Face frame application

The current 40 mm cup holes can not be used with the new hinges. Follow the steps below to replace your new hinge into your frame cabinet.

Panel application

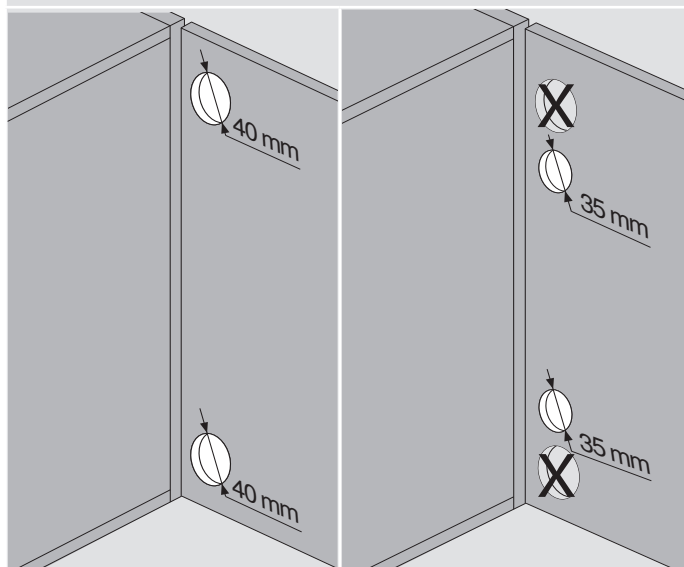
The current 40 mm cup holes can not be used with the new hinges. Follow the steps below to replace your new hinge into your panel cabinet.

- 1 Pre-bore two new cup holes at $\varnothing 35 \times 13$ (1/2")
- 2 Install new hinges into holes, attach with #6 x 5/8 wood screws
- 3 Connect hinge arm to mounting plate, ensure secure connection by distinctive "click" sound
- 4 Align door and hold in position, mark screw hole positions for mounting plate on the hinge-side panel
- 5 Attach mounting plates with #7 x 3/4 wood screws

NOTE: Screw hole locations for the wing mounting plate should be 37 (1-7/16") from the edge of the end panel to the screw hole locations
